# Recall Campaign

NHTSA#: 13V-071

**ACTION REQUIRED:**

Inspect breaker gap for minimum 3/8" gap. Repair if gap is less than 3/8"

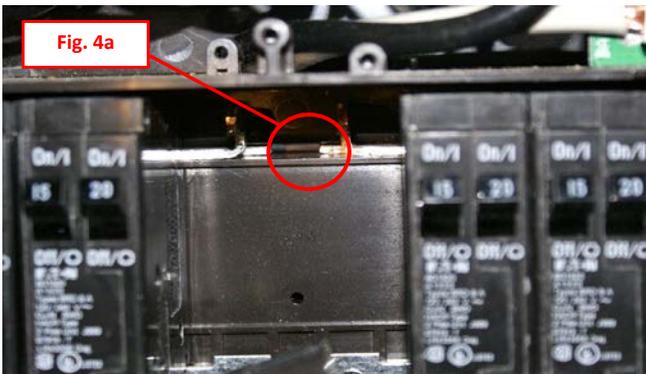
4. Using a screwdriver or similar tool that is 3/8" wide, measure the gap between the breaker plates (**Fig 4a**). The minimum gap should be 3/8". If the gap is 3/8" or more, return the breaker and screws to the original position, and there is no additional repair required. If the gap is less than 3/8" proceed to step 5.

5. Remove the remaining breakers. Remove the screw holding the breaker plate. Remove the plate.

- Using a tin snips or similar tool, trim the end of the breaker plate. NOTE: Be sure to trim the end of the plate that is in the center of the load center where the gap is measured.

- Re-install the trimmed plate and re-measure the gap. If the gap is still less than  $\frac{3}{8}$ " , remove the plate and trim off more. If the gap is  $\frac{3}{8}$ " or more, reassemble the load center.
